DESIGN COMMISSION REGULAR HYBRID MEETING AGENDA

2. Design Standard Review (DSR) 23-013

3. Design Standard Review (DSR) 23-014

12/19/23

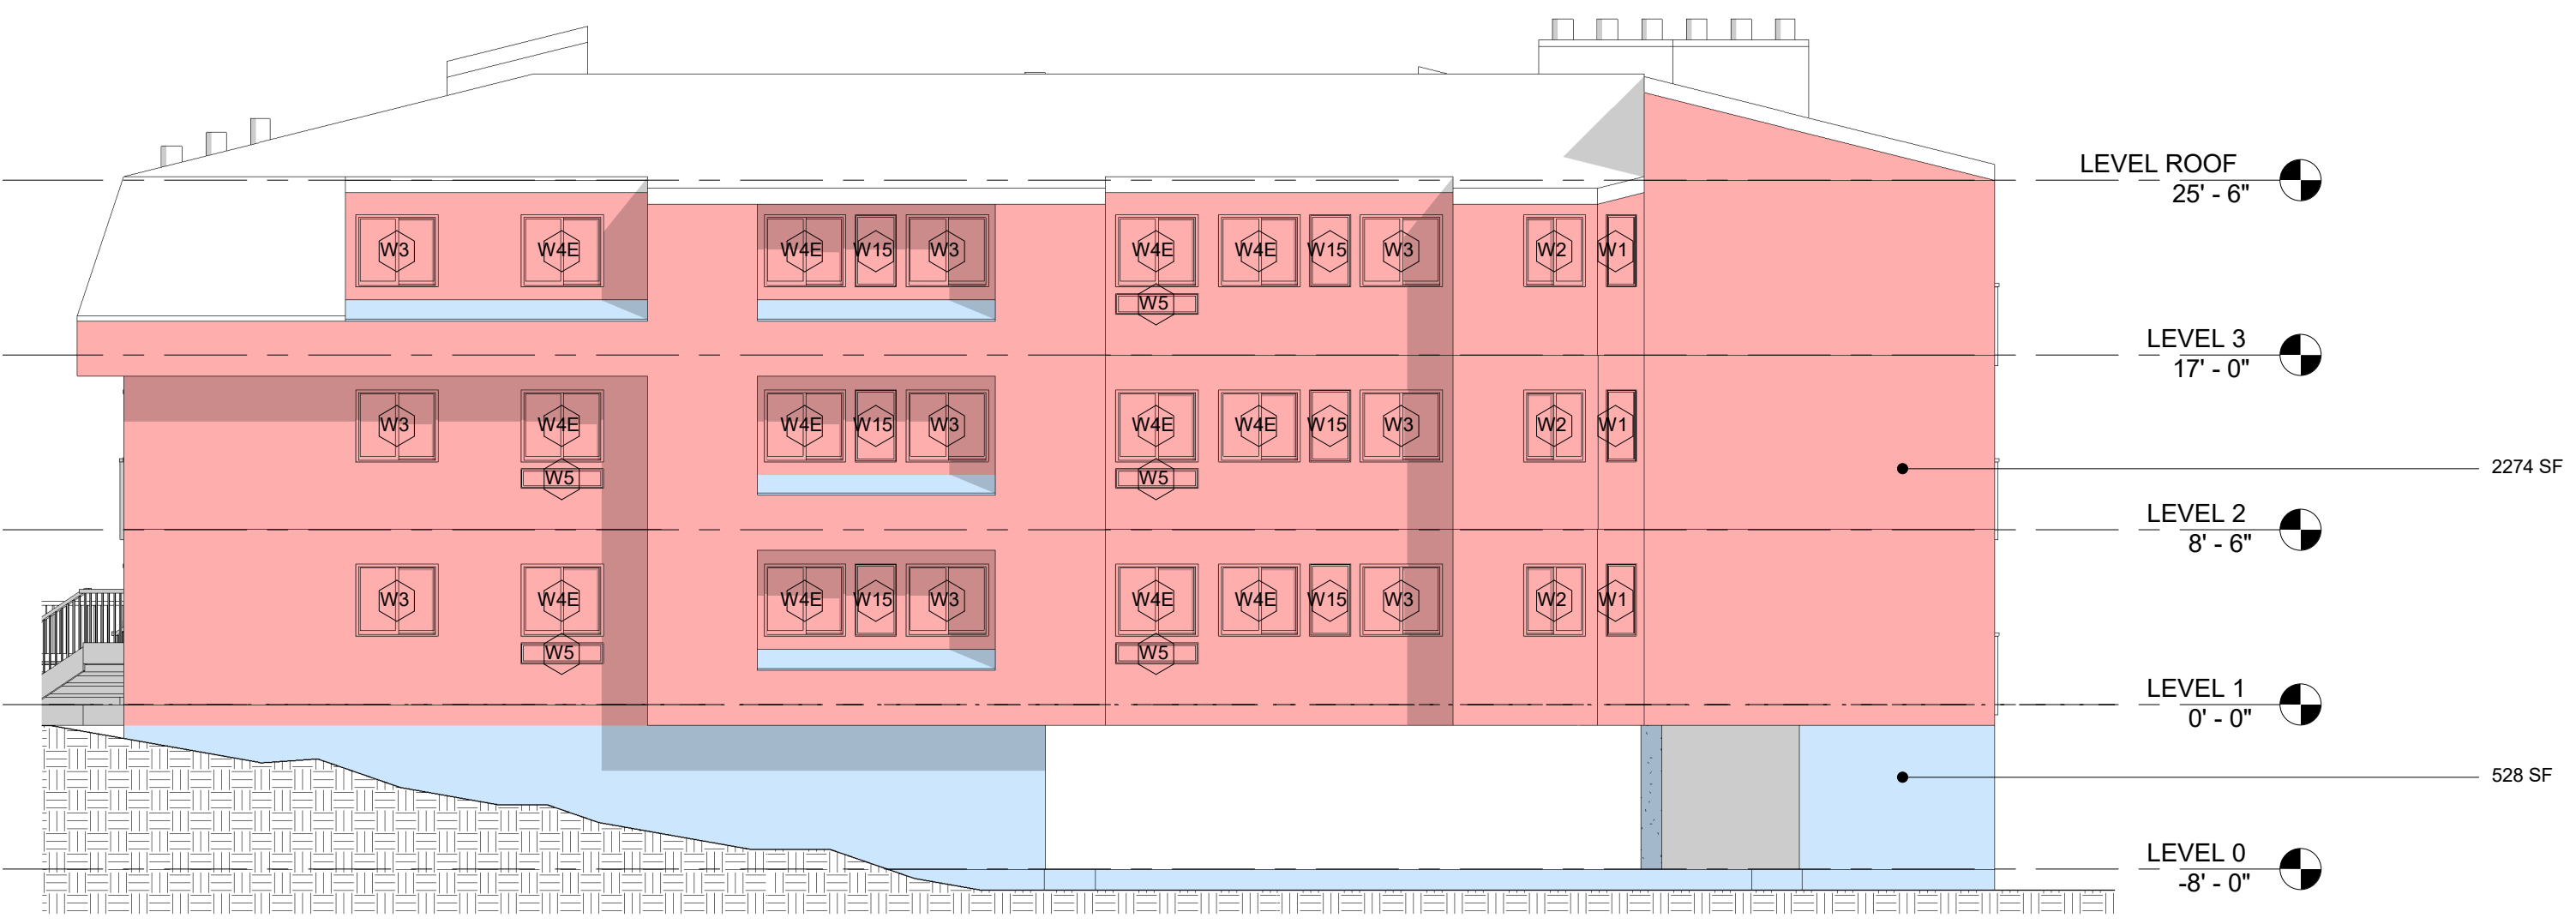
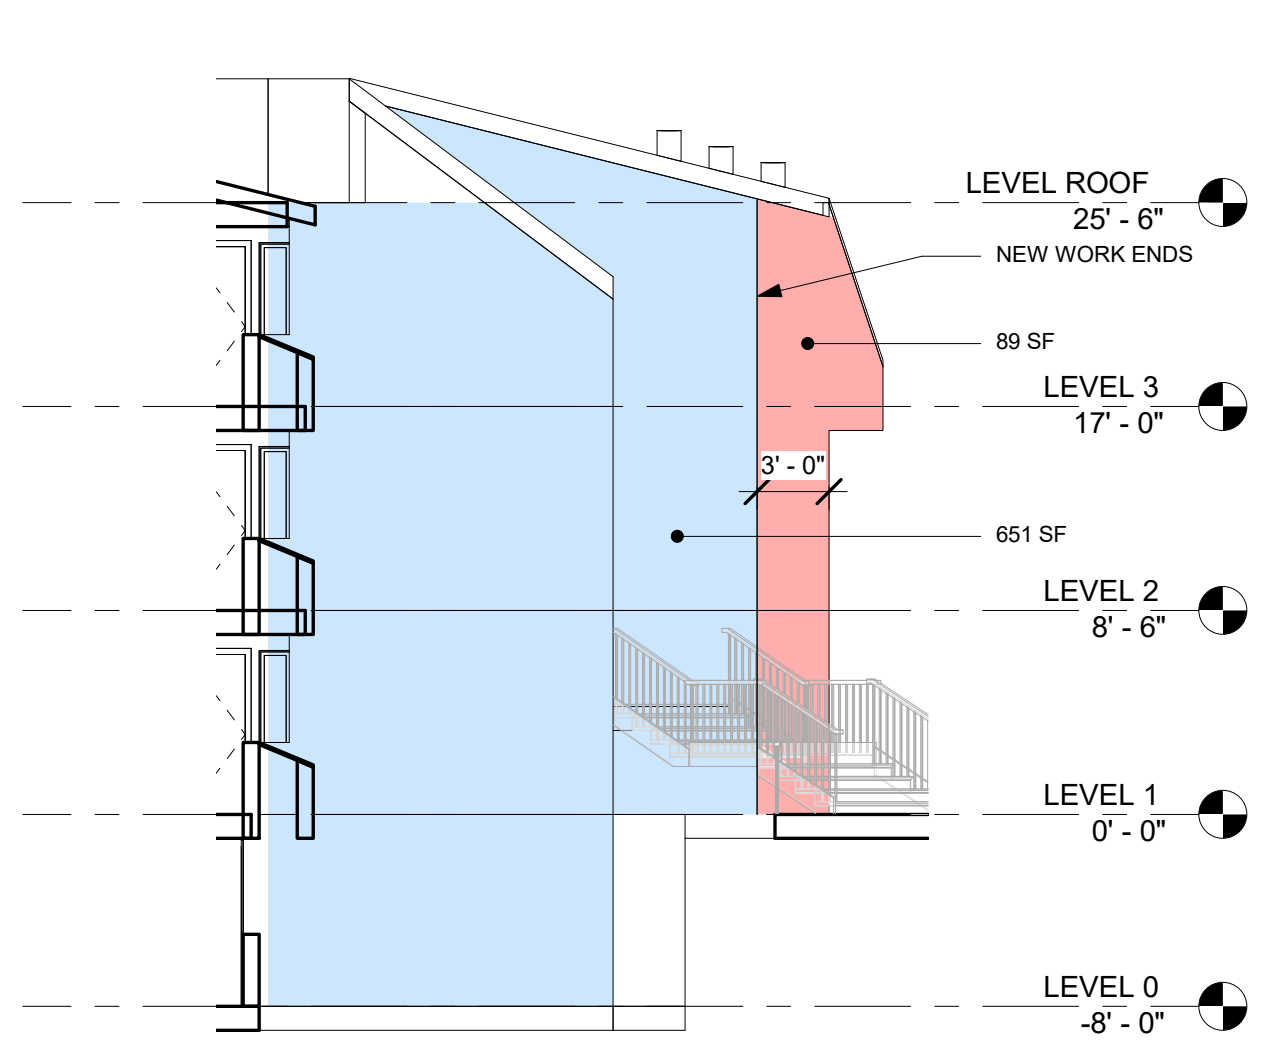
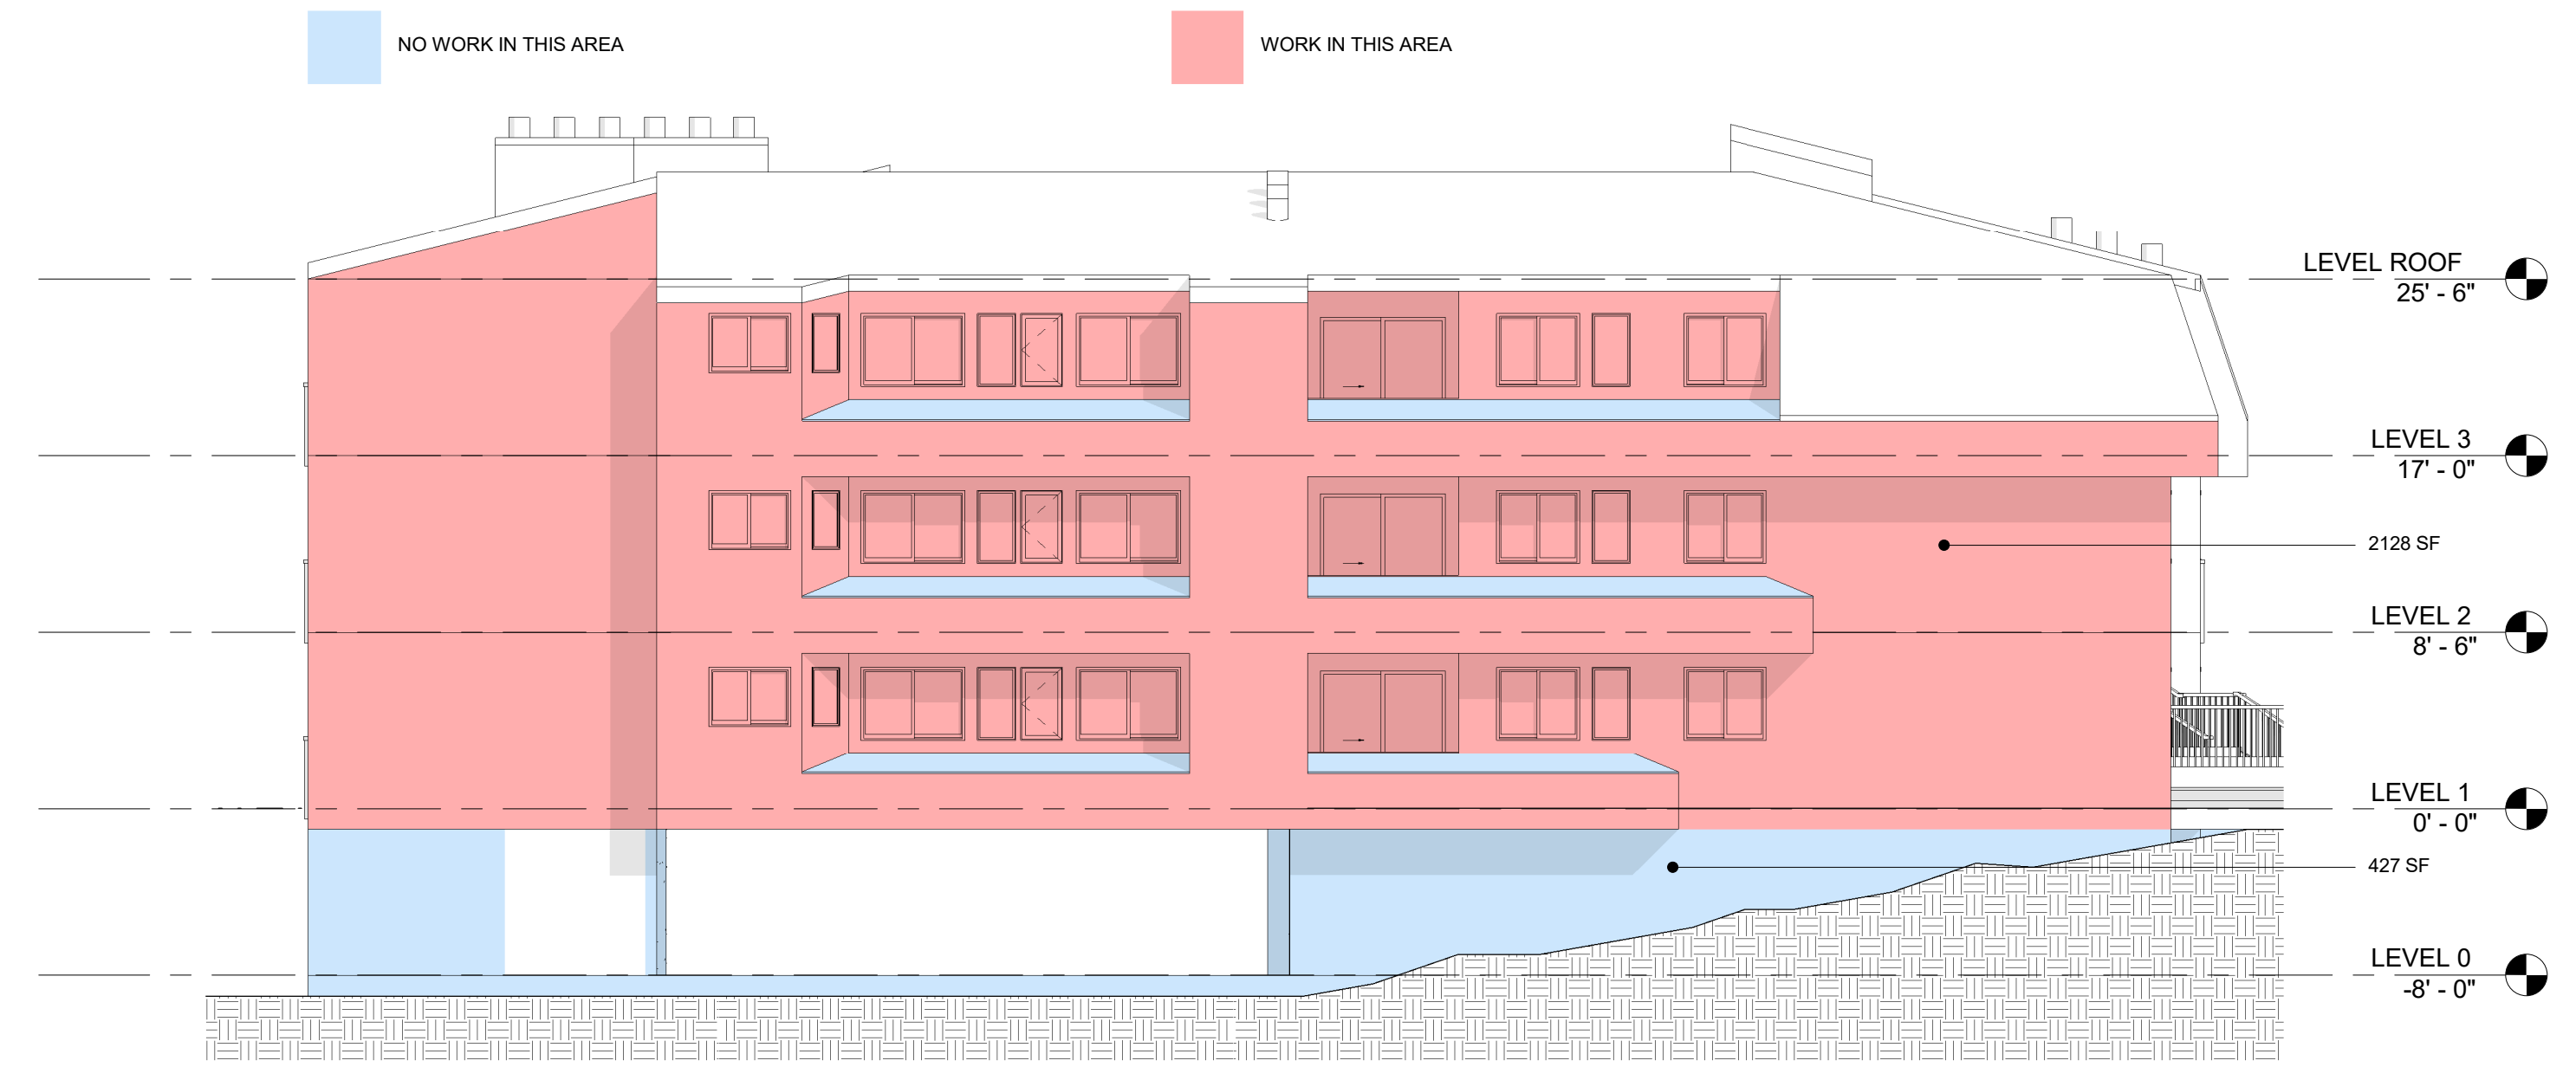
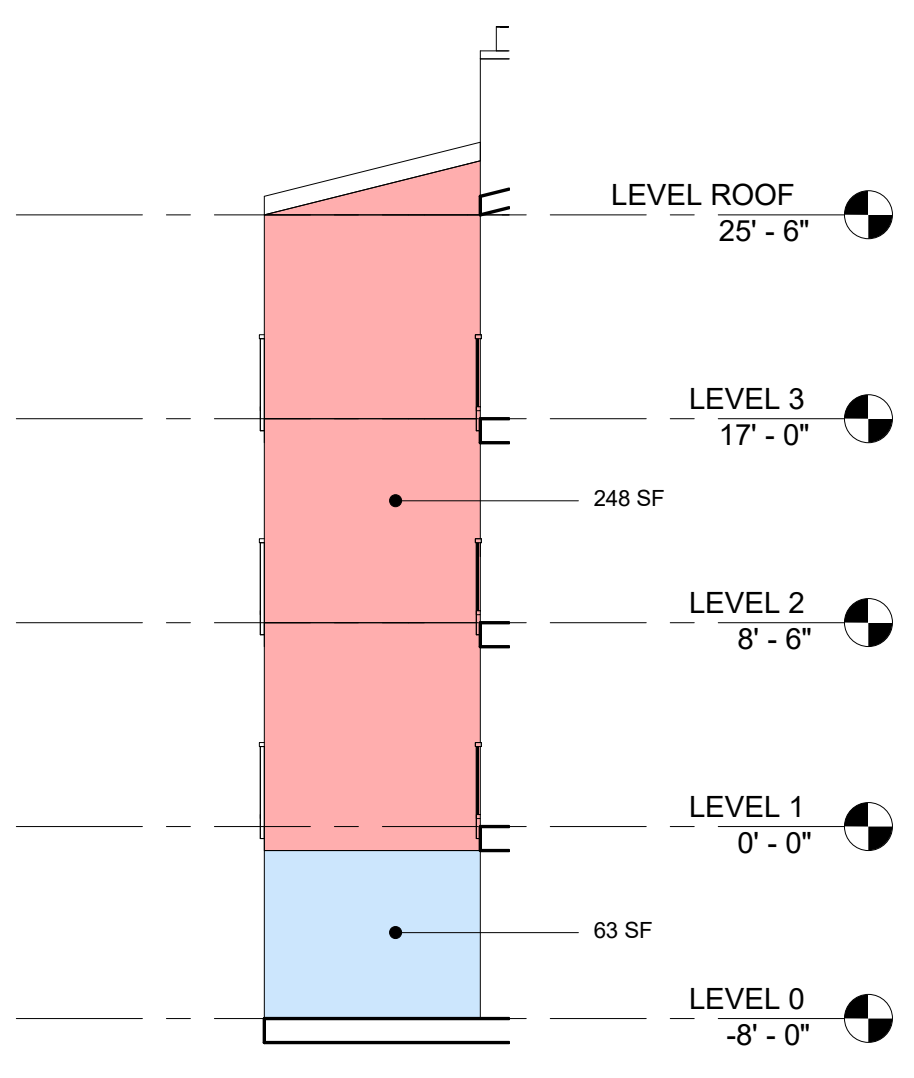
2. Glass guards are shown on the elevations to replace existing half-wall guards. The elevations provided show glazing fully bounded between structural stanchion with a structural top and bottom rail. Confirmation of existing structure to attach the stanchions shown will be part of the building permit scope. Glazing in guards is

regulated by WSBC 2407, and any deviation from the guard type shown (to a structural glass system with button attachment, or a glazed baluster panel with or without top rail) will require specialized detailing.

A-001

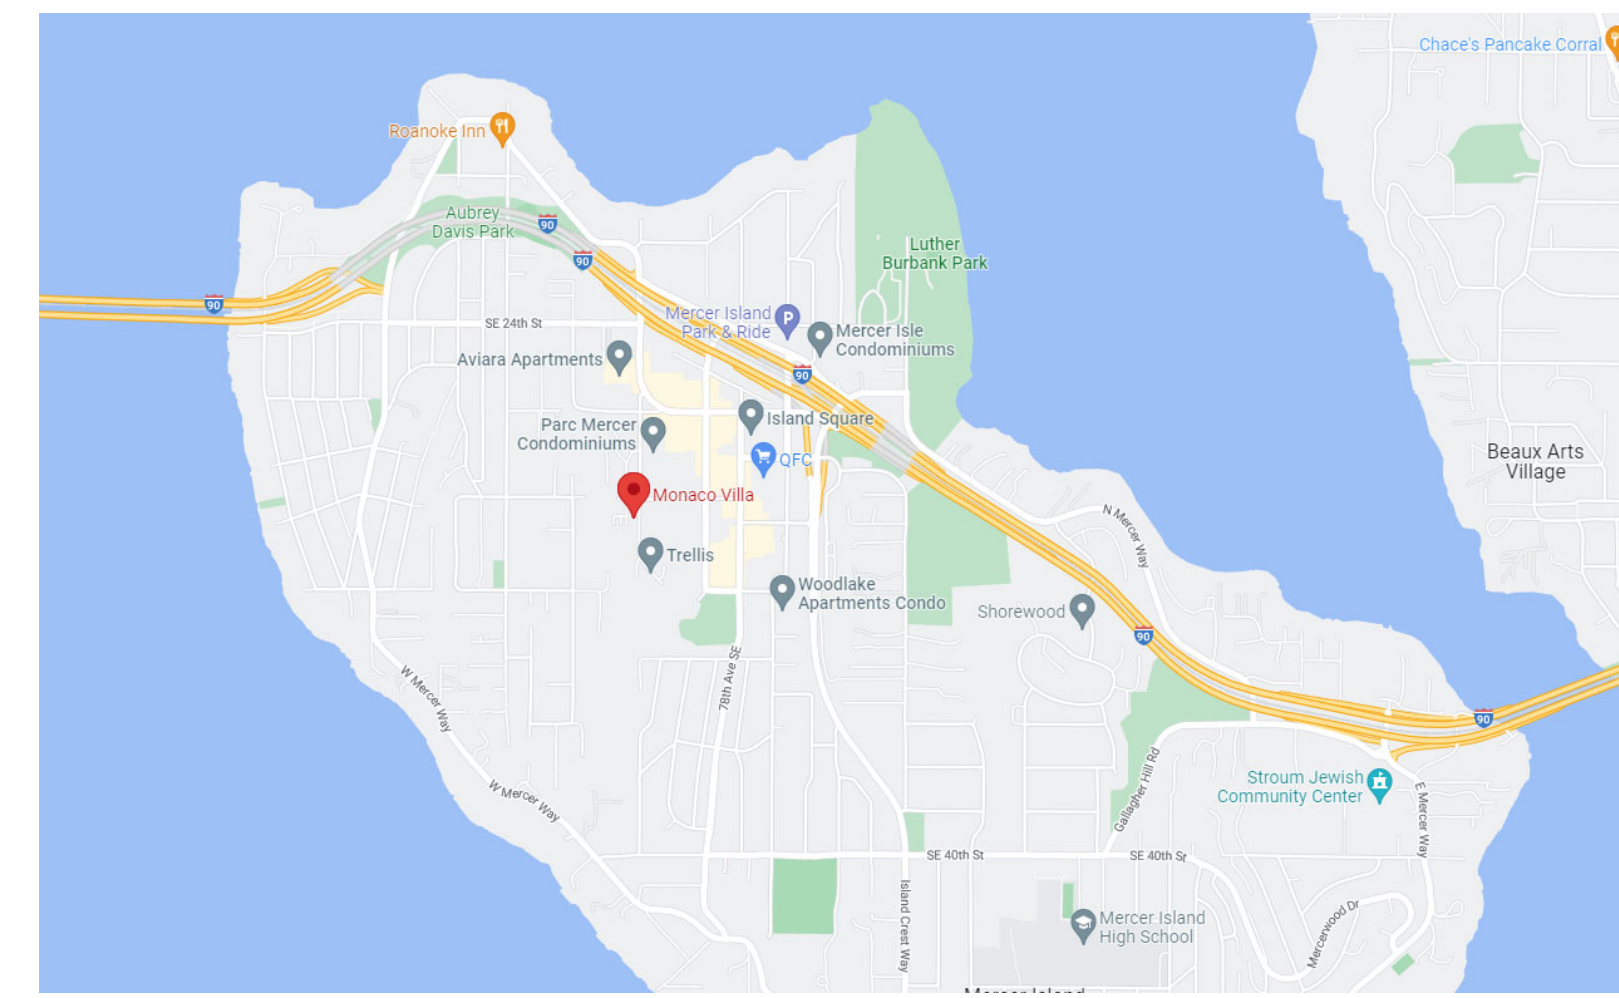
Since the date of that meeting, Building Permit 2311-202 has been issued which relates to the construction in the lobby. The scope of work noted on A-001 of the DSR23-014 materials includes "repair and modify the existing unit decks to enhance drainage and provide rail walls and railings." It is not clear from the documents if this will change exterior appearance of the existing structure.
